File 1981-0085

Project Name: Rusty Sun Subdivision – Final Plan-SegoServ.

REVIEW SHEET SUMMARY

FILE NO. 85-81 DUE DATE 9/14/81
 ACTIVITY Rusty Sun Subdivision
 PHASE Preliminary Plan & Annexation to PR 8.4 ACRES _____
 LOCATION NW corner 29 Rd. & F Rd.
 PETITIONER Sego Services c/o Jim Lindell
 PETITIONER ADDRESS 842 25 Road, Grand Junction, CO 81501
 ENGINEER Paragon Engineering, Inc.

RUSTY SUN - FILING NO. ONE
CITY OF GRAND JUNCTION, COLORADO
UTILITIES COMPOSITE

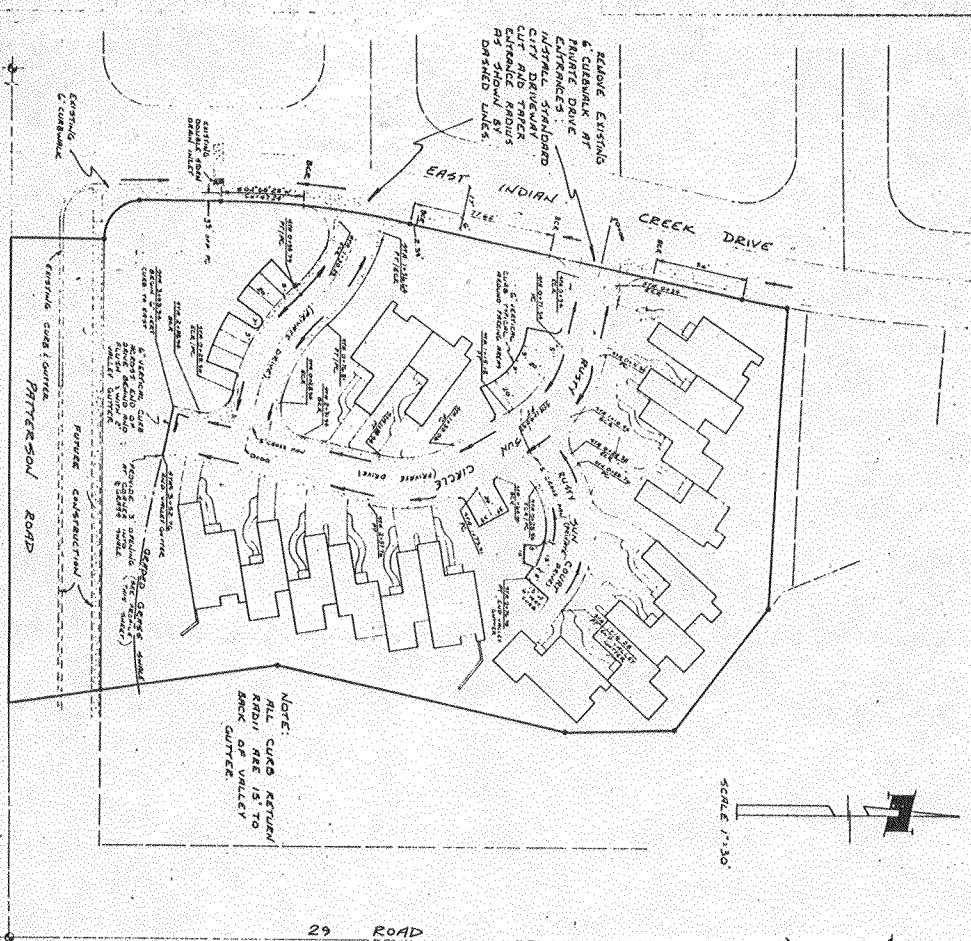
<u>DATE REC.</u>	<u>AGENCY</u>	<u>COMMENTS</u>
	Staff Comments	1) This filing #1 is quite different than the approved preliminary plan. If approved per preliminary why the change? It is ridiculous to spend time reviewing a preliminary under the assumption the final will have little or minor changes. There are major changes here which will require full re-review by the various agencies. This creates problems which the agencies shouldn't be forced to do. They make their recommendations based on the preliminary plan to be incorporated into the final plan. The changes on filing #1 are not the result of the review agencies comments, but in fact are changes by the petitioner. The quality of this filing #1 is not of final phase development and should be considered a preliminary phase 1. 2) Need to resolve parkway issue per CC prior to final submittal to Grand Junction Planning Commission. For example: 16 approved units now requesting 21 units 1) No parking on private drive should be allowed. 2) Realignment of roads needs re-review, from 2 to 1 access. 3) Turn-around needs re-review. 4) No dimensions for drive provided and some driveways inadequate. 5) Set-backs have changed from 17' to 10' on north side. 6) Signage may have sight-distance problem. 7) No detailed signage submitted. 8) Under utilities notes - it states "locations shown are proposed and do not reflect the final design" This is the final plan and plat.

PRELIMINARY DEVELOPMENT PLAN
RUSTY SUN TOWNHOMES
GRAND JUNCTION, COLORADO
GRADING, DRAINAGE AND UTILITY PLAN

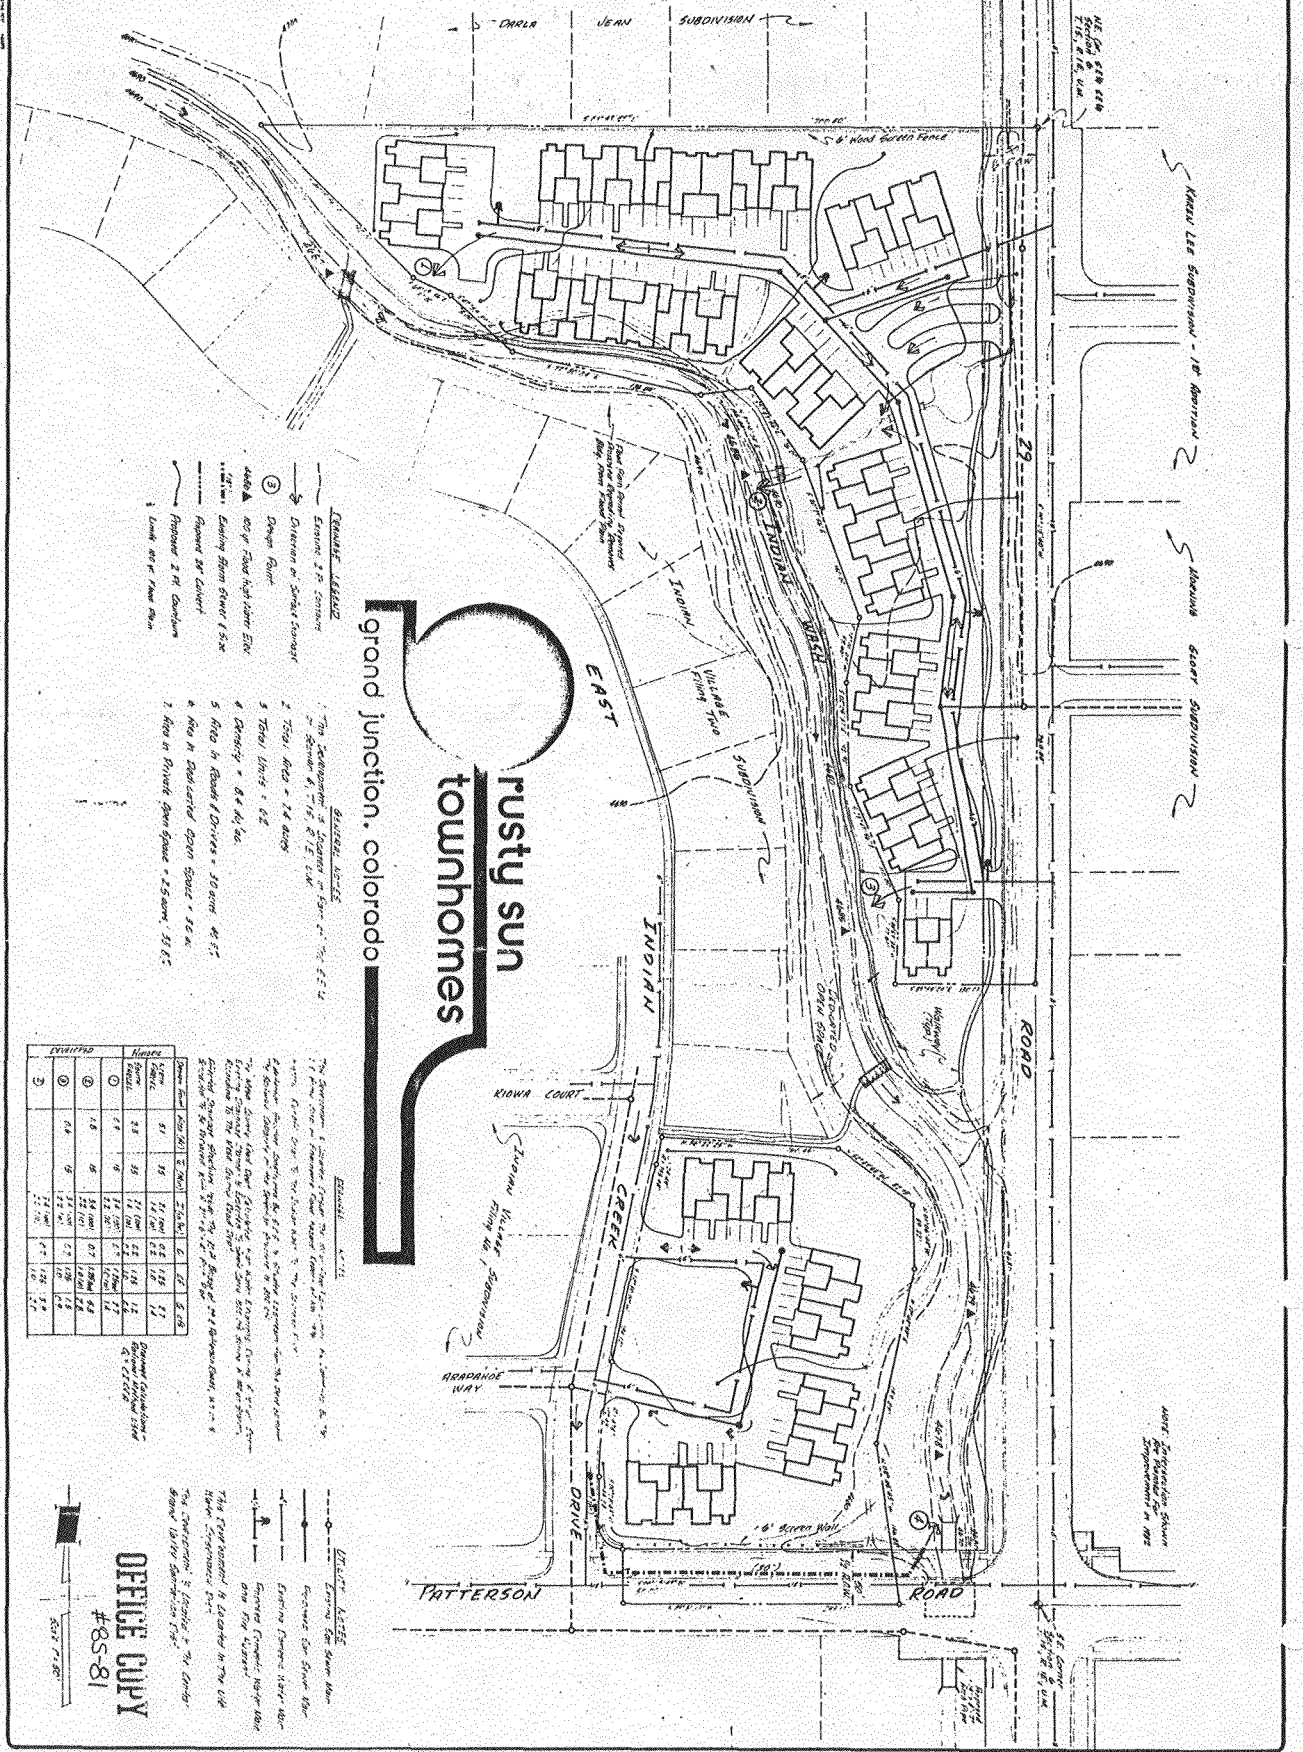
9/11/81	G.J. Drainage	Drain parallel with 29 Road along east boundary must be tiled with 24" concrete pipe. Contact this office for detail.

9/14/81	Floodplain Admin. City	Due to the indication of regrading of the channel, a floodplain analysis will be required to show the effects of both up and down stream prior to preliminary approval. A floodplain permit will be required prior to any construction. All construction will have to conform to Grand Junction Floodplain regulations. Also there are indications of bridges (pedestrian?) across the wash, thus size, dimensions etc. of piping, channel, modifications is required and will need to be approved by the appropriate agencies prior to final approval. May be required to go thru 404 permit process.
9/14/81	City Fire	Hydrant locations as shown on utility plan are ok. The water line on development off 29 Rd. to be 8". The looped 6" line off East Indian Creek is OK. We will need address system on buildings. Hydrants will have to be installed before construction starts on the different phases. Fire flow will be required. This office has no objections to preliminary plan and rezone, if above conditions are met.

Comprehensive Planning	<p>The impact statement clearly indicates the changes of the immediate neighborhood. These include:</p> <ol style="list-style-type: none">1) The establishment and approval of the existing Indian Village, Darla Jean, and Karen Lee Subdivisions.2) The establishments and their approvals of multiple family zones within one half mile of radius of the site, including Sunrise Gardens, Pepperidge, and Wood-smoke.3) Sanitary sewer mains and domestic water mains have been extended into the area.4) 29 and Patterson Roads have been classified as major arterials.5) The establishment of a neighborhood commercial shopping center located South East of 29 and Patterson Roads.
Grand Junction Drainage	Drain ditch paralleling 29 Road will be abandoned and diverted to a point further North of its present discharge. As indicated on the submitted grading and drainage plan. Any tiling will be done with a 24" concrete pipe.

<u>Agency</u>	<u>Response</u>
Mountain Bell	Comments were informational in nature.
City Flood Plain Administrator	Refer to response to comments previously stated to the County Flood Plain Administrator. Additionally, the southerly most bridge has been removed from the development plans.
City Fire	Had no objections to the Preliminary Plan and Rezoning and found the hydrant locations shown on the utility plan to be ok.
City Engineer	<p>The proposed street improvements shown on 29 and Patterson Roads, fit the Mesa County proposed intersection improvements.</p> <p>It is petitioners intention to construct the additional roadway requirements for 29 Road adjoining the site in question. The balance of 29 Road along the Wash will be part of the County street improvement plans for 1982.</p> <p>Easements will be granted for the drainage channels to the Indian Wash.</p> <p>Revised plan indicated that all buildings are removed from the designated 100 year flood plain.</p>

- 10) The 100 year flood plain is designated on the submitted grading and drainage plan.
- 11) As previously stated, landscaping details will be submitted with the Final Development Plan.
